# CERTIFICATE OF APPROPRIATENESS PLACARD

218 N EAST STREET

HECK-POOL HOUSE

049-15-MW

TOP VIEW  
to scale

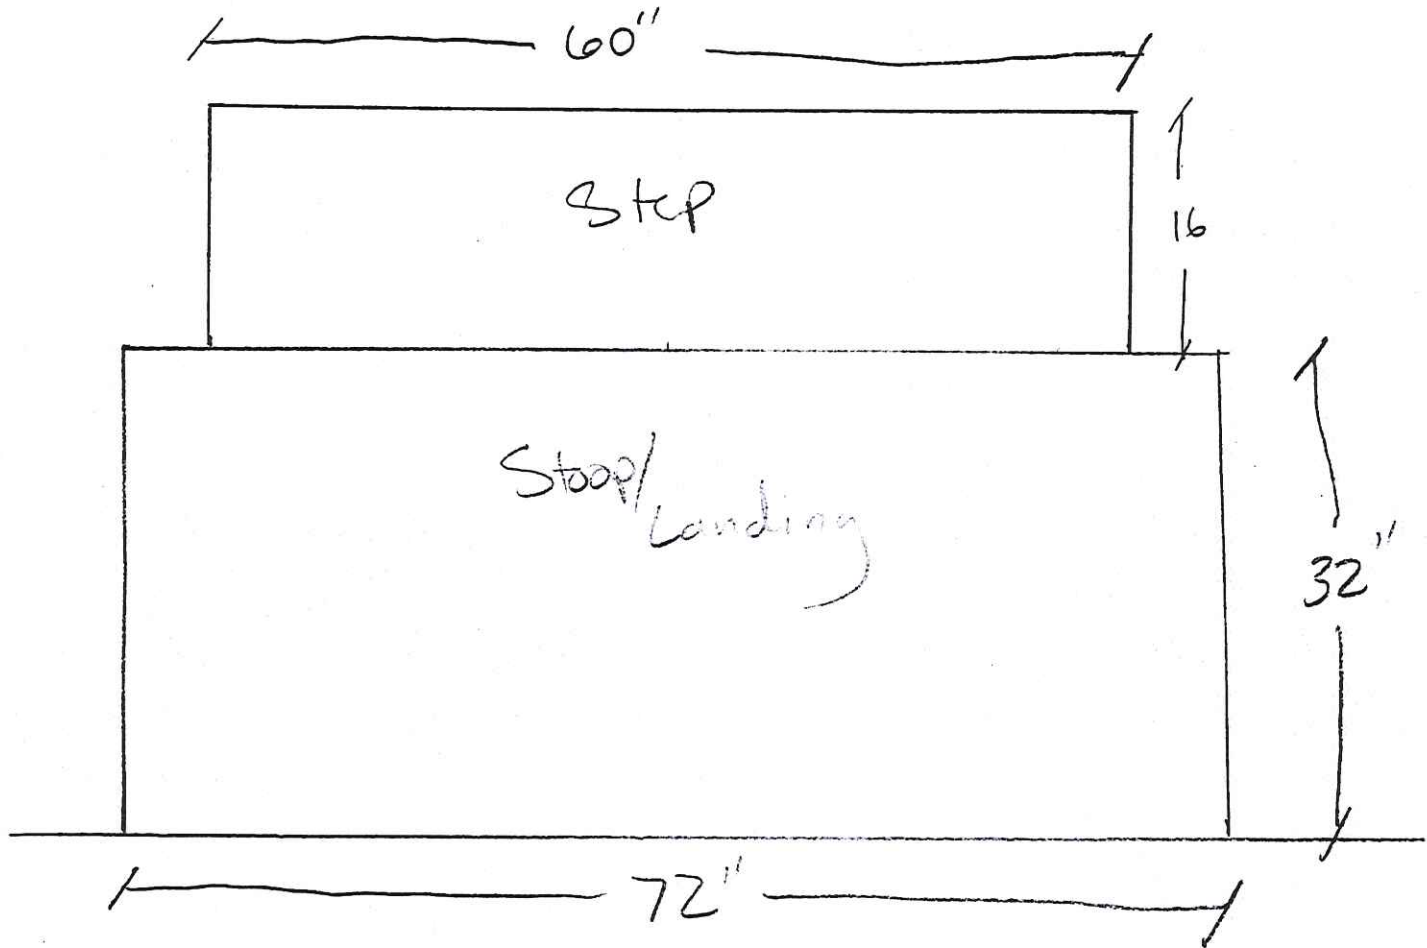
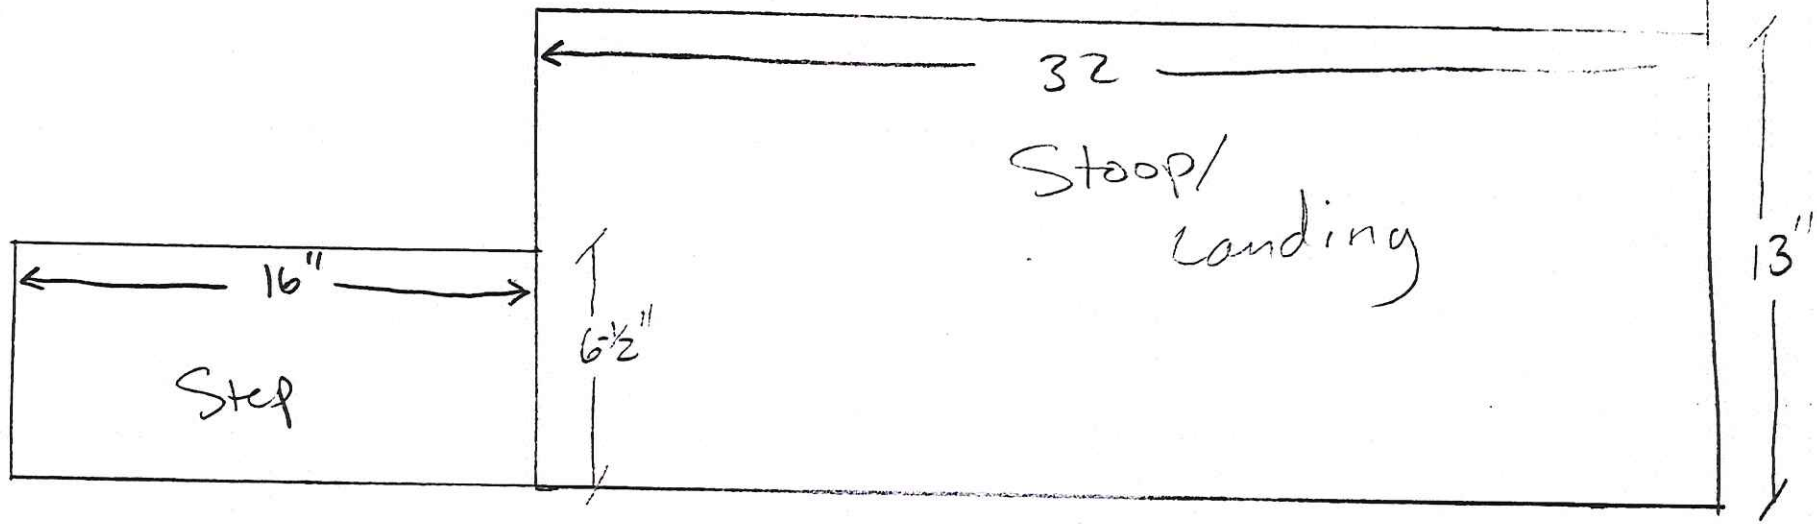
Thanks for the sketches. I have the following final (I hope) questions.

- 1) Per the remainder of the application these steps are brick – correct?
- 2) The written description states there will be a brick landing, steps and walk, but none of the drawing submitted show a brick walk. Am I missing something? If there is intended to be a walk I need a drawing with the location and dimensions.

Yes...the same Phoenix.

I apologize. We intend to add a walk later but didn't intend to include it on this application. Is it possible to remove the walk from the COA?

I'll use this email as your amendment to the COA to eliminate the request for a walk way to accompany the steps and landing.
